3/4.9.9 WATER LEVEL - SPENT FUEL STORAGE POOL

BSEP SPENT FUEL POOL STORAGE EXPANSION

Analysis I.D. 80011-M-02-F

FIGURE 1

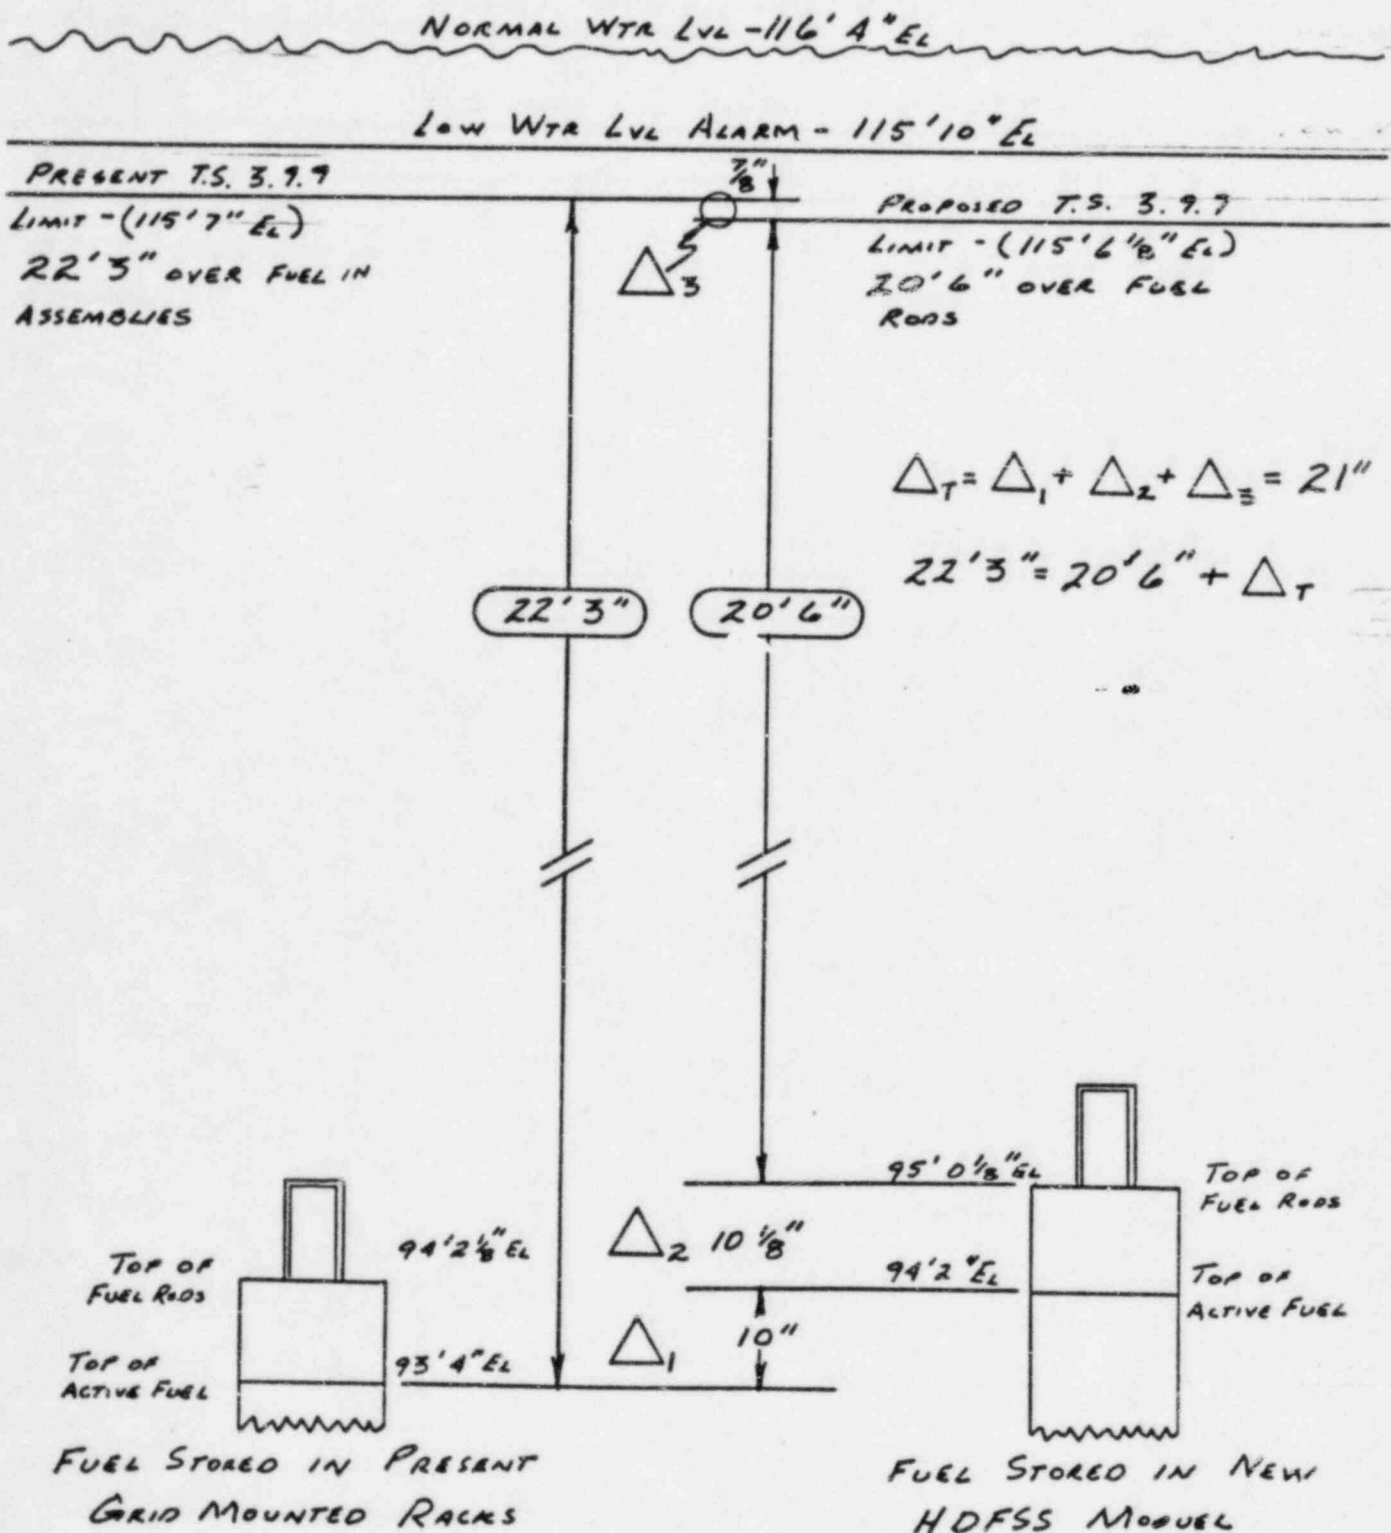
DEMONSTRATION OF NUMERICAL DIFFERENCE
IN WATER DEPTH BETWEEN NEW HDFSS
MODULES AND OLD GRID MOUNTED RACKS

NOTE: THIS INCLUDES BOTH A REDUCTION OF WATER DUE TO THE HIGHER HOFSS RACKS PLUS A CHANGE OF REFERENCE FROM TOP OF ACTIVE IRRADIATED FUEL ASSEMBLIES TO TOP OF FUEL RODS.

3.9.9 At least 20 feet 6 inches of water shall be maintained over the top of the irradiated fuel rods seated in the spent fuel storage pool racks.

7.2 THE BSEP TECH. SPEC. 3.9.9 CAN BE SAFELY REDUCED TO 20'6" OF WATER TO BE MAINTAINED OVER THE TOP OF THE FUEL RODS FOR FUEL STORED IN THE SPENT FUEL STORAGE RACKS.
